**TOWN OF MOUNTAIN VILLAGE  
 DESIGN REVIEW BOARD SPECIAL MEETING  
 Sketch SPUD Initial Architecture Review Public Hearing Agenda  
 TUESDAY, MAY 17, 2022 2:00 PM  
 MOUNTAIN VILLAGE TOWN HALL  
 455 MOUNTAIN VILLAGE BLVD, MOUNTAIN VILLAGE, COLORADO  
 TO BE HELD HYBRID THROUGH ZOOM:**

RE: Lot 161CR Procedures – SPUD Sketch Plan -- May 17, 2022 DRB Meetings

**RE:** **Part I.** CLASS 3, SKETCH SITE SPECIFIC PLANNED UNIT DEVELOPMENT (SPUD) Initial architecture review, for Lot 161C-R, Lot 67, Lot 69R-2, Lot 71R, OS-3Y, and portions of OS-3BR2 and OS-3XRR for a mixed-use hotel/resort development including plaza, commercial and residential uses  
**Part II.** CLASS 3, SKETCH SITE SPECIFIC PLANNED UNIT DEVELOPMENT (SPUD), final architecture review, for Lot 161C-R, Lot 67, Lot 69R-2, Lot 71R, OS-3Y, and portions of OS-3BR2 and OS-3XRR for a mixed-use hotel/resort development including plaza, commercial and residential uses

**Exterior Wall Form – Village Center Wall Form Additional Requirements (CDC 17.5.6.B.2b)**

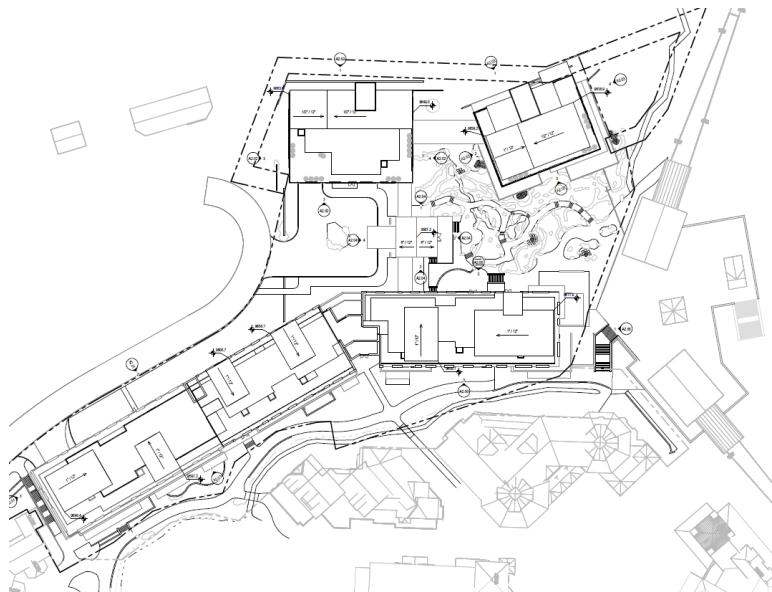
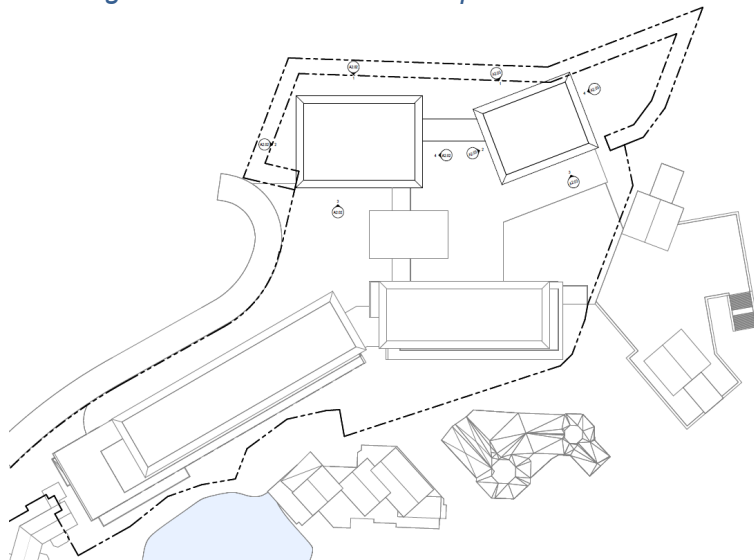
*Staff: A change in materiality generally differentiates commercial areas from residential areas above, with the looser stacked stone indicating commercial use and the honed stone veneer*

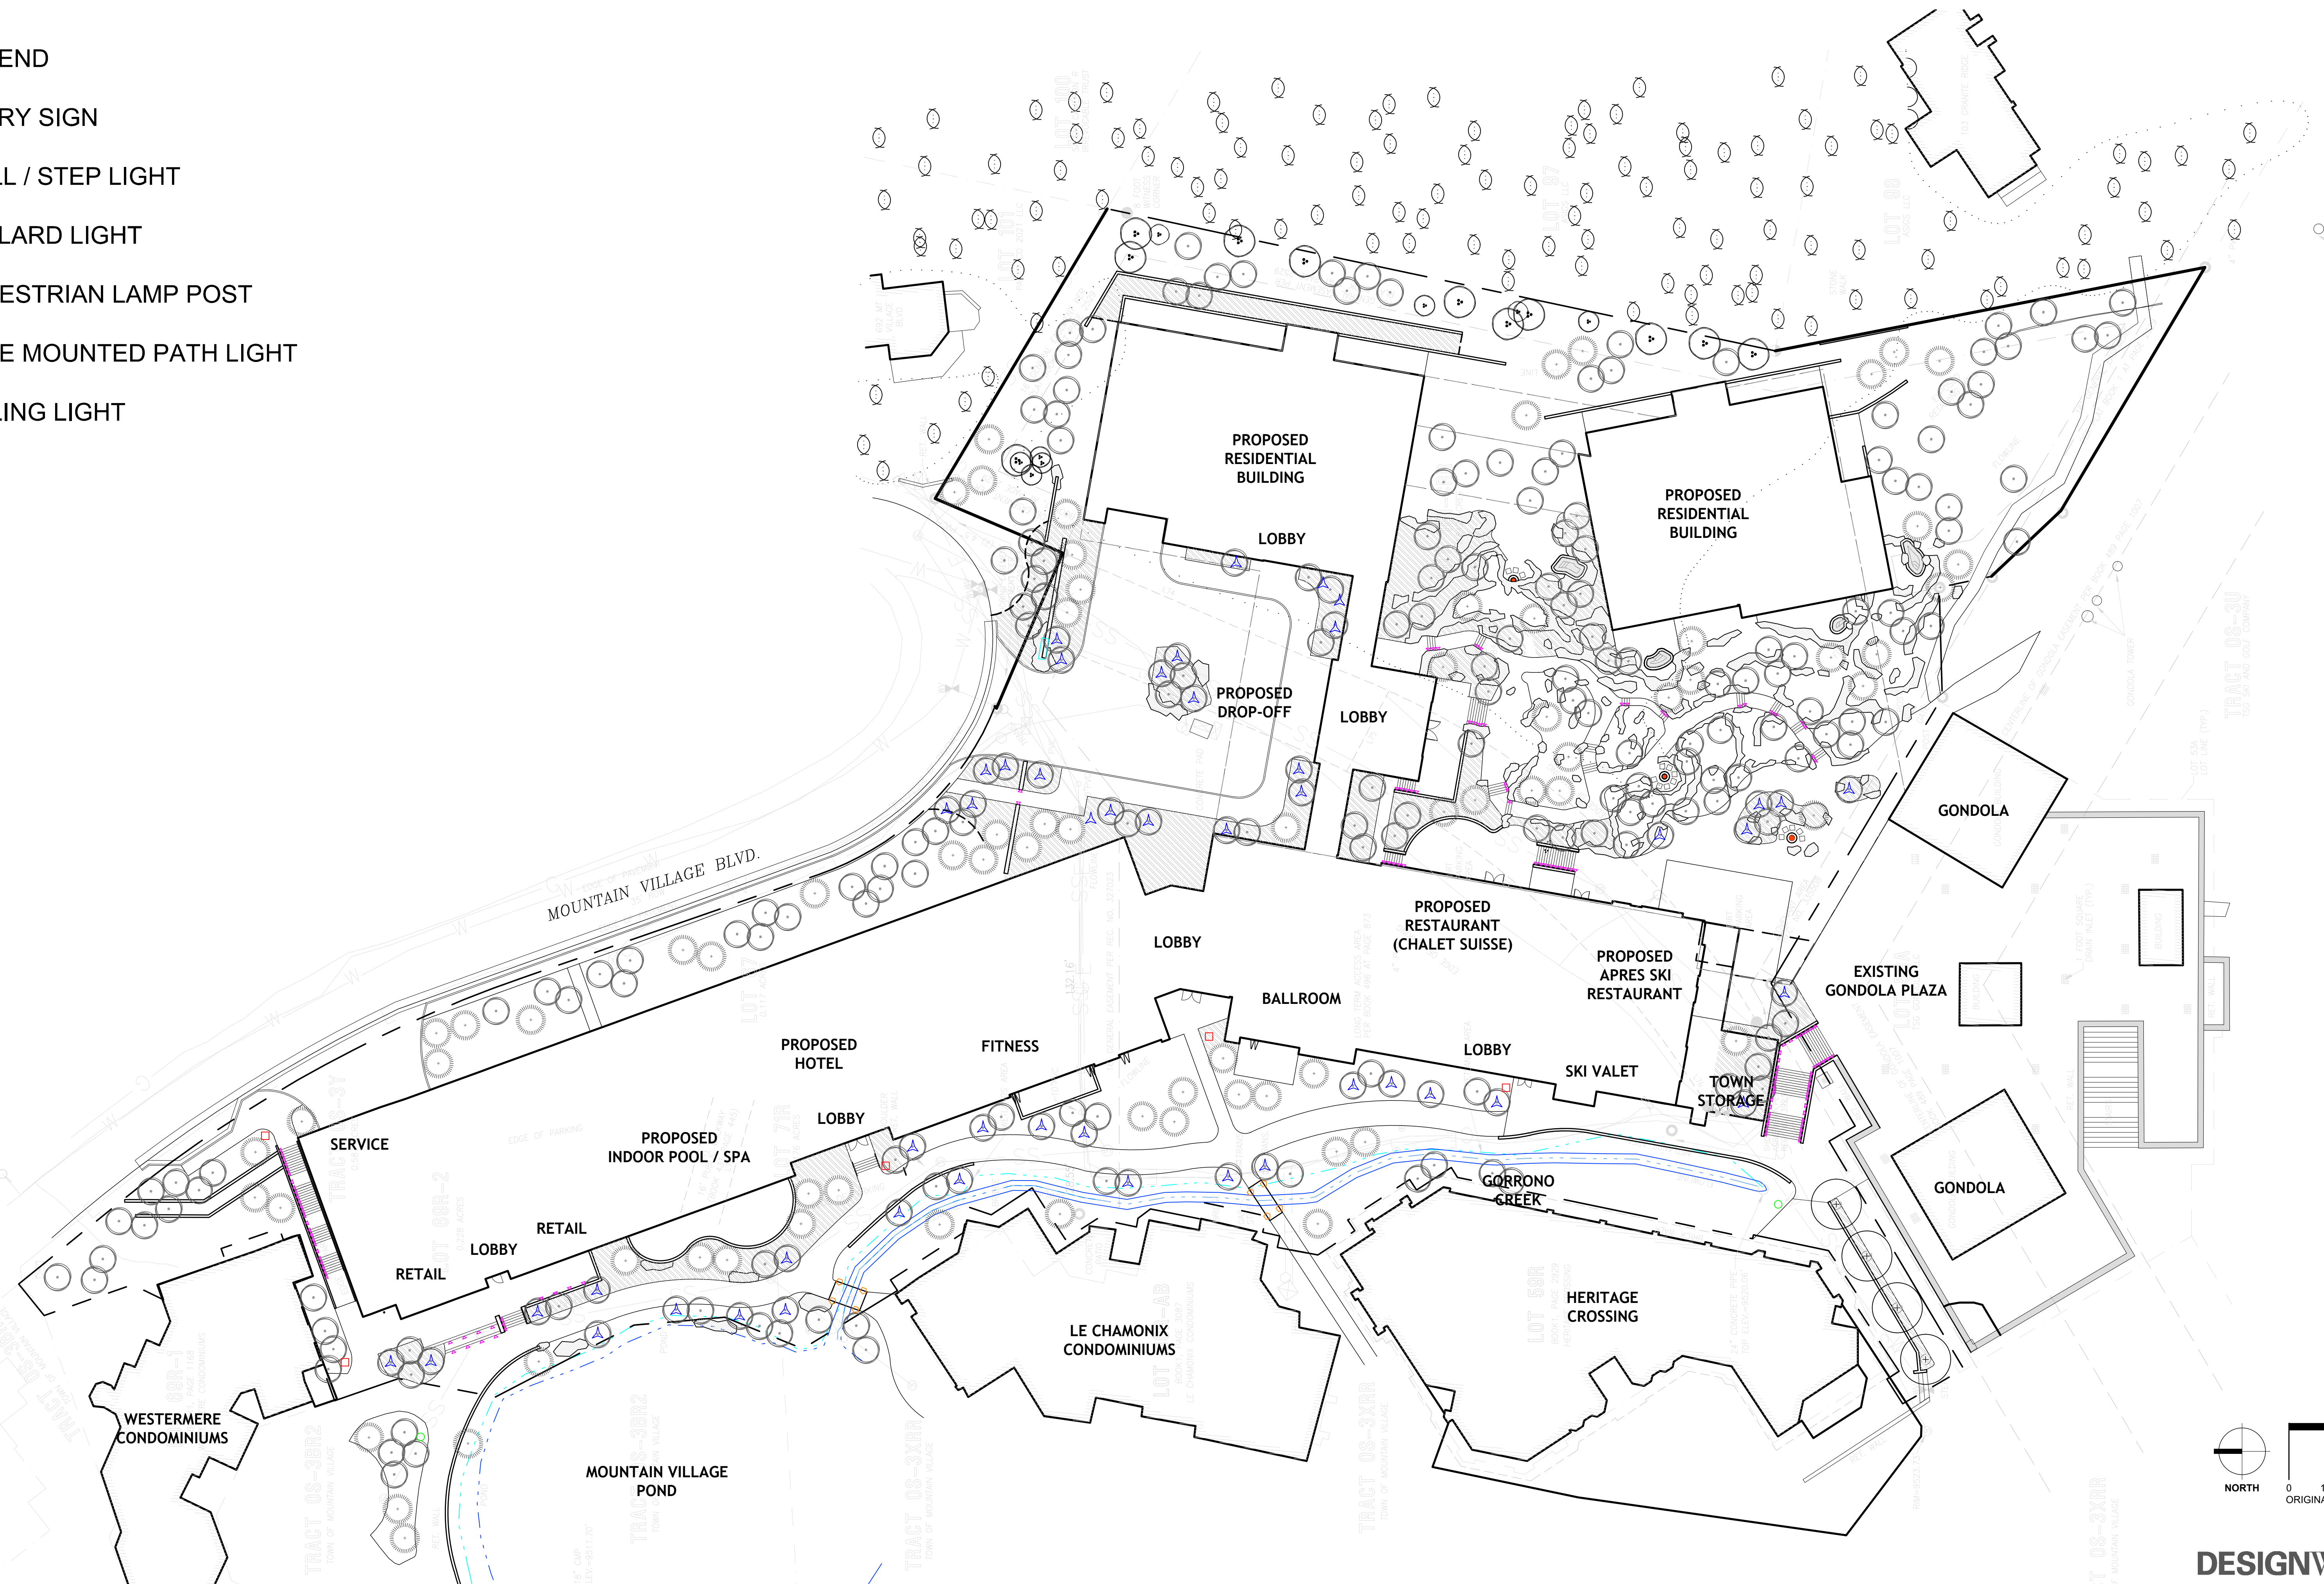
*Staff: It should be noted that the lighting plan is not required until final review. The plan that has been provided shows only landscape lighting, not exterior fixtures on the building. There are a few issues which should be discussed by DRB with the current submittal.*

*There is also some provision in the code as to the use of lighting near delineated wetland areas. The code states, "The use of exterior lighting shall be minimized in areas of important wildlife habitat and delineated wetlands, and lighting shall be designed so that it does not spill over or onto such critical habitat." The photometric study does show some light spill at the wetland boundaries along the edge of the pedestrian path, mostly keeping it to .1 or .2 footcandles, with the exception of a few areas which show a max light of .4-.6 foot candles. Staff believes this lighting plan shows that the plan has been minimized to meet this provision and provides the minimum level of lighting that still allows for the public safety of pedestrians.*

11. *Prior to final review the applicant shall revise the landscape lighting plans per the direction of DRB members at this meeting. An updated lighting plan for exterior fixtures on the building, including specification sheets for each fixture as well as photometric study shall also be provided.*
